Basement sketch 3/9/17 hhw

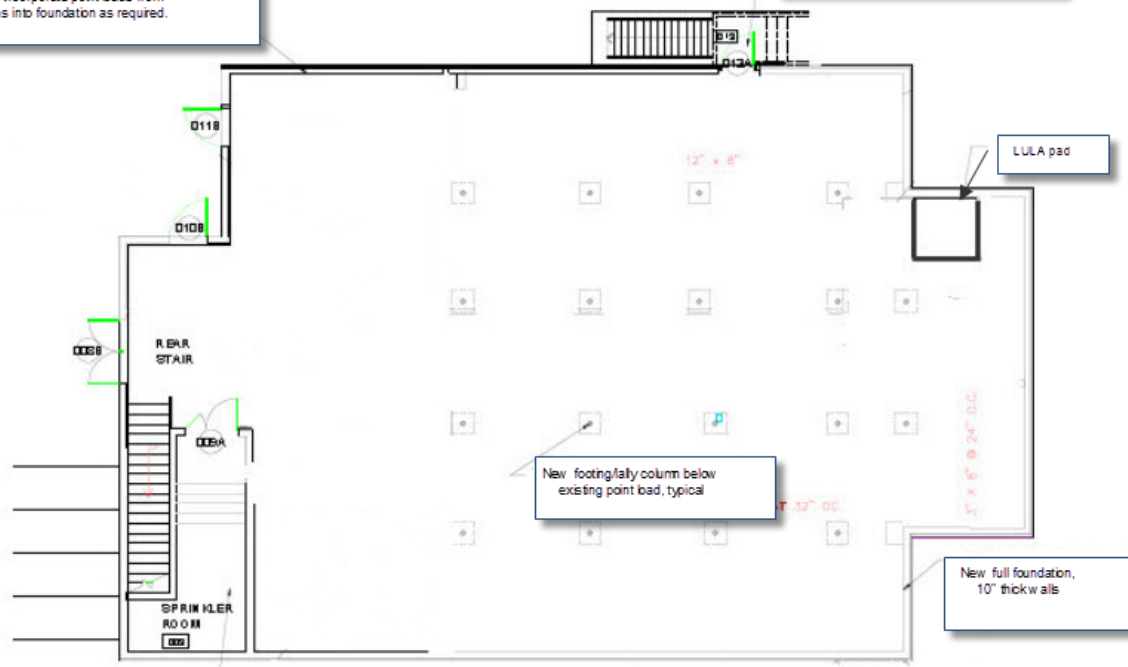
Infill area below second floor dressing room, incorporate point loads from columns into foundation as required.

New second exit from basement.

Depressed sprinkler room to allow for gravity feed to sprinkler pump
